**From:** [REDACTED]  
**To:** [A47 Blofield to North Burlingham](#)  
**Cc:** [REDACTED]  
**Subject:** TR010040 - A47 Blofield to North Burlingham - Response from Blofield Parish Council - Unique Reference: A47B-SP013  
**Date:** 19 May 2022 14:09:33  
**Attachments:** [REDACTED]

### **Application by National Highways Limited ("the Applicant") for an Order granting Development Consent for the proposed A47 Blofield to North Burlingham Project.**

<b>Regulation Number:</b>	Rule 8(1)(e)
<b>Planning Inspectorate Scheme Reference</b>	TR010040
<b>Application Document Reference</b>	8.13
<b>BIM Document Reference</b>	HE551490-GTY-LSI-000-RP-TX-30045
<b>Author:</b>	A47 Blofield to North Burlingham Dualling Project Team, National Highways

### 1. Highways England a. Cucumber Lane Roundabout

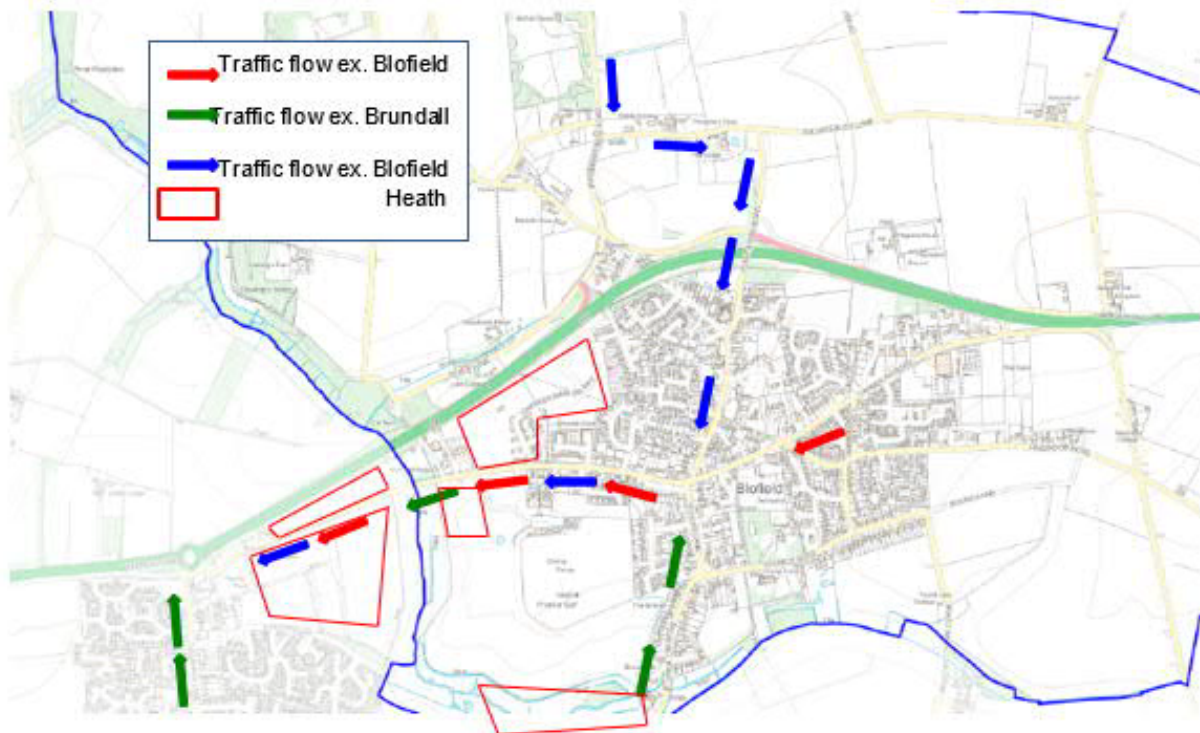
Traffic routes (as indicated on the map) show traffic emanating from Blofield Heath, Brundall and Blofield itself all concentrating on this junction. Already traffic on the A47 approaching from the East (Acle / Gt. Yarmouth) approaches the junction at high speed and volume causing congesting at the roundabout for traffic joining from the villages, causing tailbacks at peak times.

Both Highways England and Norfolk Highways refuse to perceive this as a problem either now or in the future and have resisted taking a proactive approach to the problem by planning ahead instead positioning themselves on a "wait and see" approach.

Local knowledge already sees this as a problem waiting to happen but no authority will take responsibility for resolving in advance. All that has been tabled are, on the building of a further residential development towards said roundabout, minor changes to the roundabout layout and some minimal road widening on the approaches. Insufficient in the opinion of the local Parish Councils.

### **b. Traffic flow through the village**

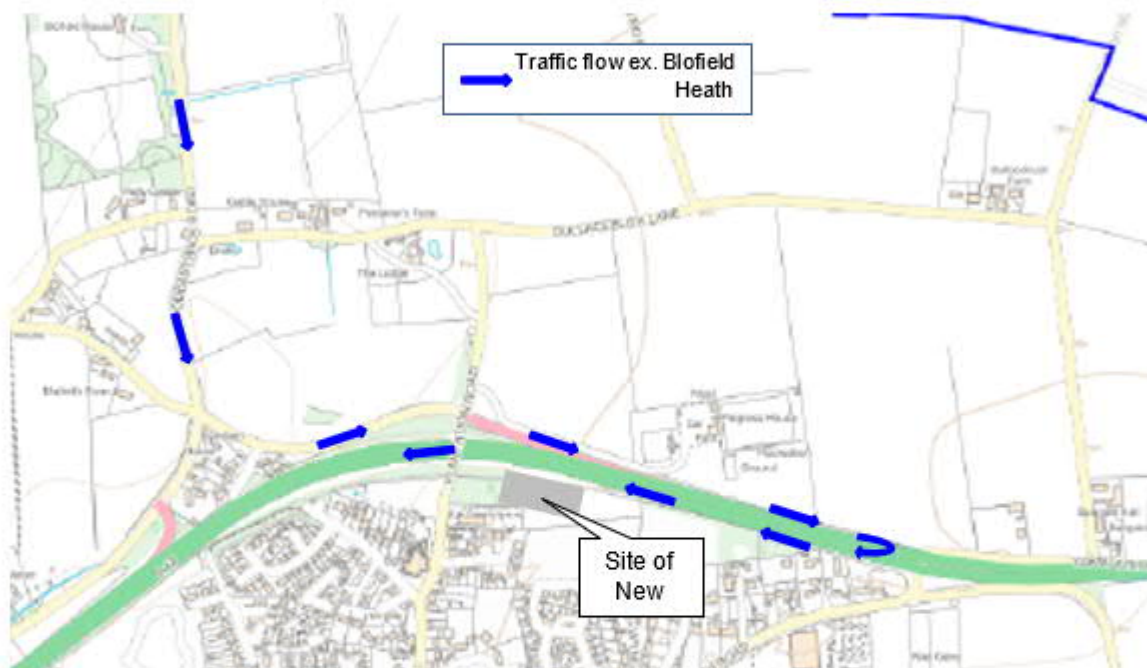
During Consultation with Highways England on the proposed plans for dualling from Blofield to North Burlingham it became apparent that a reasonable number of Blofield Heath residents were travelling south out of their village towards Blofield, using the slip road to join the A47 East towards Acle and using the gap in the central reservation (access to east end of Blofield) to execute a U-turn at this junction to join the A47 WEST towards Norwich.

As part of the dualling scheme Highways England plan to close this break in the central reservation therefore closing off this access route towards Norwich. The consequence of this is to force all of the traffic from Blofield Heath through the already congested village of Blofield and along Yarmouth Road to the Cucumber lane roundabout (see 1a above).

Norfolk County Council also plan to build a new primary school in the next 2-3 years at the location shown on the map that is at least DOUBLE the size of the existing school thus creating even more traffic along a typical village road. As NCC had, at the point of the consultation with Highways England, not yet submitted planning applications, HE were unaware of this until advised by the Parish Council. They committed to consider this in their planning.

Figure 2

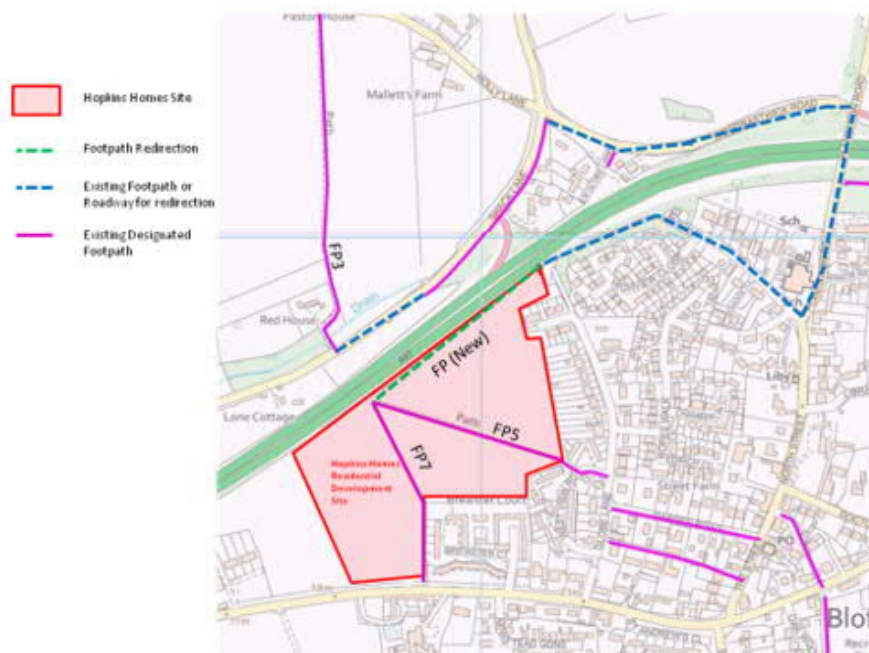
As a consequence of the above the Council is proposing to seek redirection of the footpath as outlined in Figure 2 below.

Due to limited crossing points of the A47 the redirection would be as follows :

- Establishment of new recognised footpath along the Northern Boundary going north-east to join existing footpath to North Street.
- South-east along pavement to Plantation Road
- North along Plantation Road, crossing A47 over roadway bridge
- West on Woodbastwick Road
- South-west on Shack Lane to rejoin FP3 at existing point

#### **2.3 Works Plans**

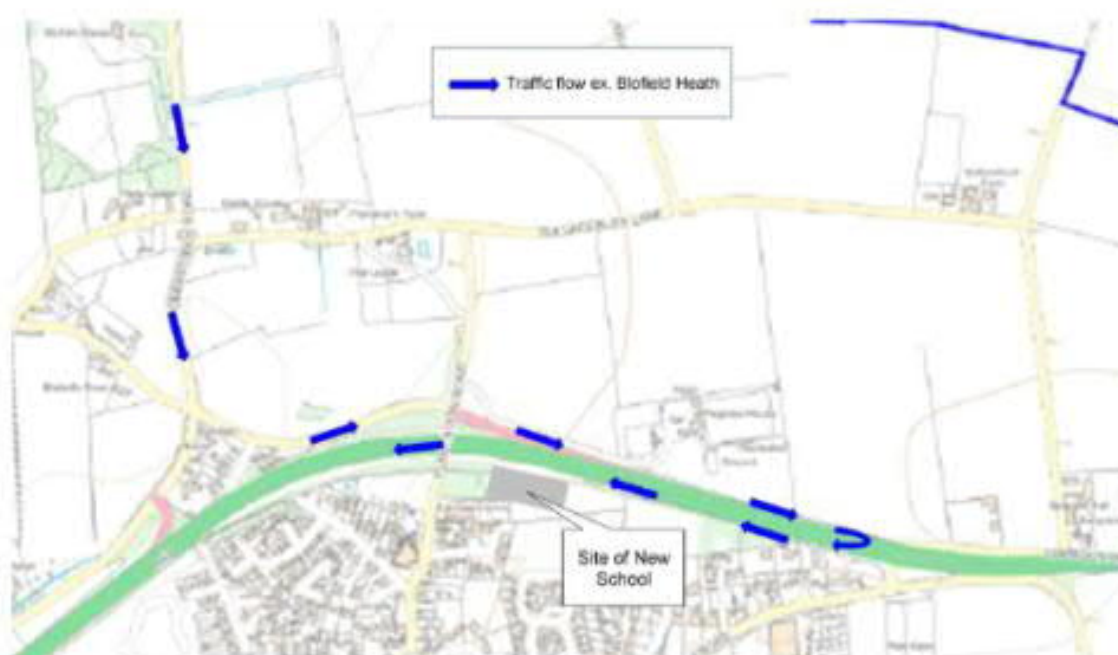
Blofield Parish Council is disappointed that the suggested alternative junction layout has been completely disregarded by Highways England.

Traffic flow from Blofield Heath suggests that a high number of parishioners are exiting Blofield Heath, travelling south towards Blofield, using the slip road to join the A47 East towards Acle and then using the gap in the central reservation to execute a U turn to then travel to towards Norwich on the westbound A47, as indicated below.

As the proposal for the A47 junction will close off the gap in the central reservation, it is our view that traffic will be forced to enter Blofield and encounter the already congested road network in the vicinity of the current school site, doctors surgery and proposed new school site for onward travel to the A47 Cucumber Lane roundabout for onward travel to Norwich.

It is with this knowledge why we proposed an alternative layout to the junction that could be achieved with minor alterations to the plans which, in our view, would alleviate the traffic flow issues demonstrated above.

**Page 3 : Cucumber Lane Roundabout:** Therefore, the implementation of the Scheme is not the underlying reason for the capacity related operational issues at the junction. **It may not be the underlying reason but shouldn't a scheme also try to resolve a recognised problem**

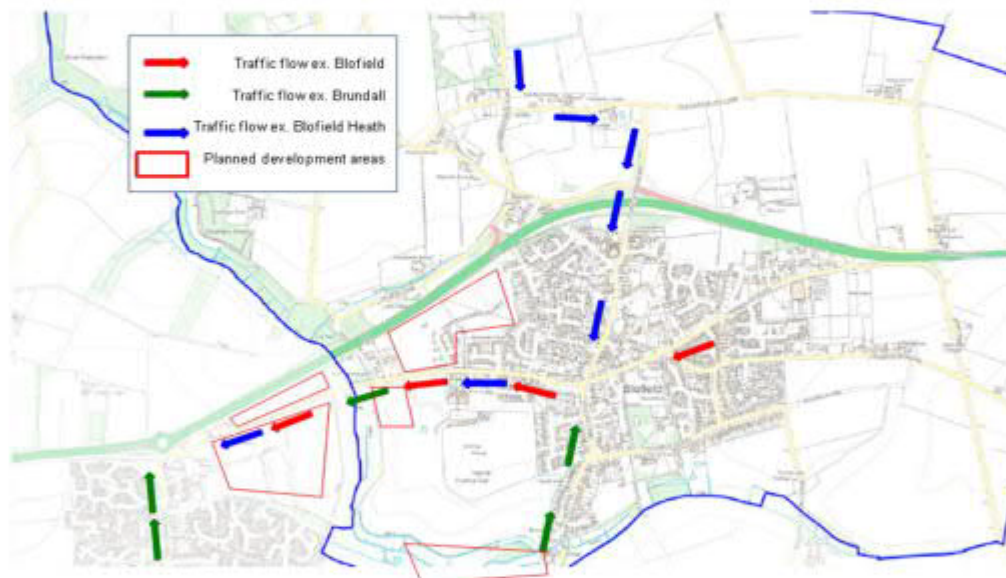
With increased existing and approved residential developments in the villages of Blofield, Blofield Heath and Brundall increased pressure on the village infrastructure continues to mount. Access West towards Norwich from these villages relies, in the main, on access to the A47 dual carriageway at the roundabout at the Cucumber Lane ( from Brundall ) / Yarmouth Road ( from Blofield ) junction.

Traffic routes ( as indicated on the map ) show traffic emanating from Blofield Heath, Brundall and Blofield itself all concentrating on this junction. Already traffic on the A47 approaching from the East ( Acle / Gt. Yarmouth ) approaches the junction at high speed and volume causing congesting at the roundabout for traffic joining from the villages, causing tailbacks at peak times.

Both Highways England and Norfolk Highways refuse to perceive this as a problem either now or in the future and have resisted taking a proactive approach to the problem by planning ahead instead positioning themselves on a "wait and see" approach.

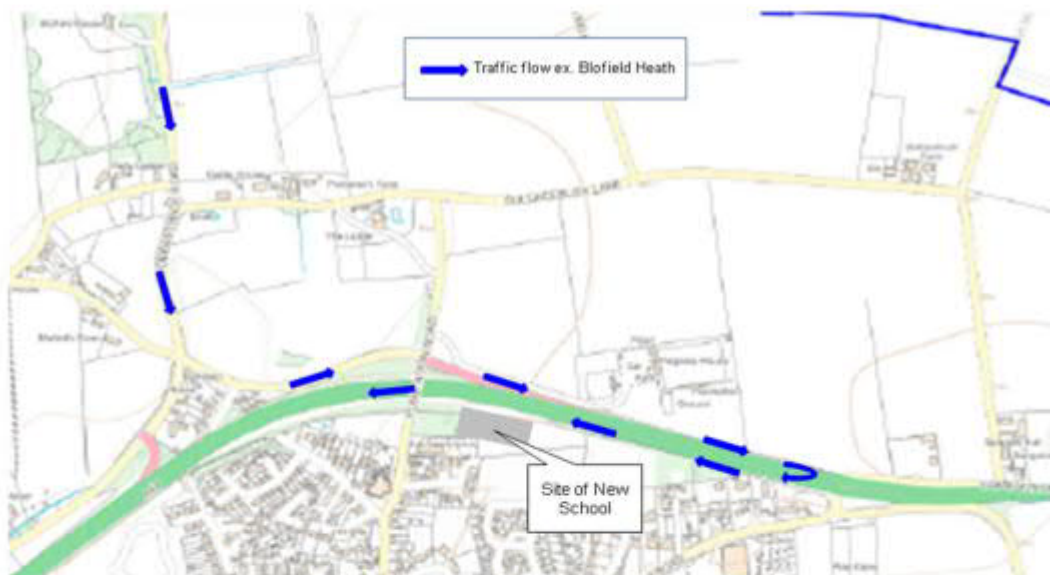
During Consultation with Highways England on the proposed plans for dualling from Blofield to North Burlingham it became apparent that a reasonable number of Blofield Heath residents were travelling south out of their village towards Blofield, using the slip road to join the A47 East towards Acle and using the gap in the central reservation ( access to east end of Blofield ) to execute a U-turn at this junction to join the A47 WEST towards Norwich.

As part of the dualling scheme Highways England plan to close this break in the central reservation therefore closing off this access route towards Norwich. The consequence of this is to force all of the traffic from Blofield Heath through the already congested village of Blofield and along Yarmouth Road to the Cucumber lane roundabout ( see 1a above).

Norfolk County Council also plan to build a new primary school in the next 2-3 years at the location shown on the map that is at least DOUBLE the size of the existing school thus creating even more traffic along a typical village road. As NCC had, at the point of the consultation with Highways England, not yet submitted planning applications, HE were unaware of this until advised by the Parish Council. They committed to consider this in their planning.

**Page 7:** Yarmouth Road Junction It is still disappointing that the alternative option has been discounted with no discussion with anyone with local knowledge. We will probably have to “agree to disagree”.

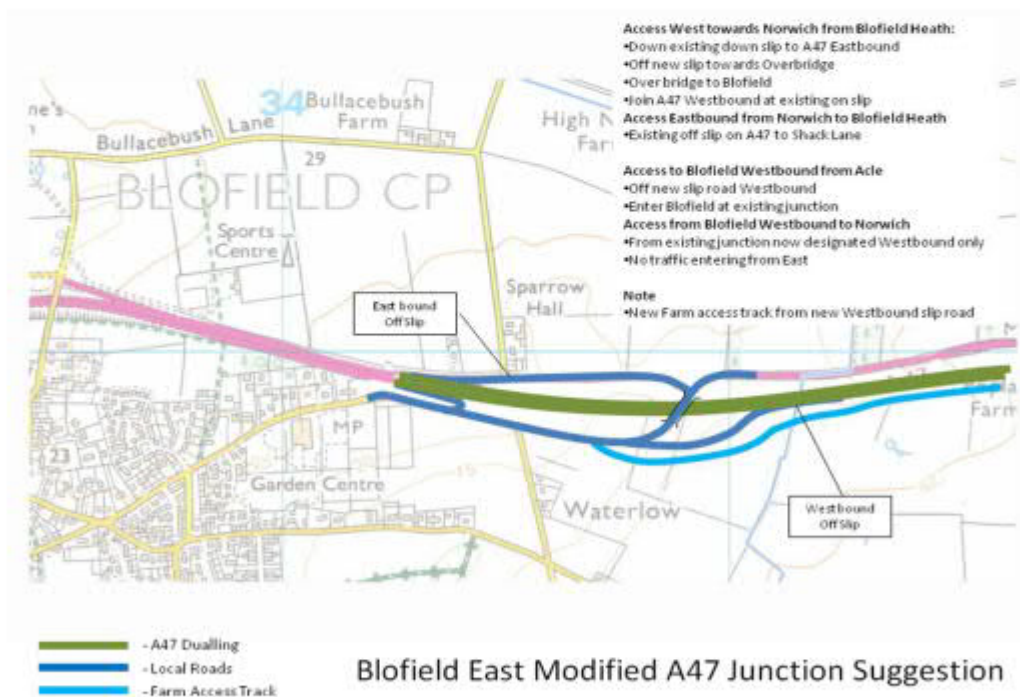
Following the meeting Blofield Parish Council proposed the alternate junction (see below ) at the eastern end of Blofield that would potential alleviate both of the issues above.

This was submitted to Highways England for consideration ( as it was felt only minor changes were required ) but has been completely ignored and discounted in the final plans and submission of the DCO.
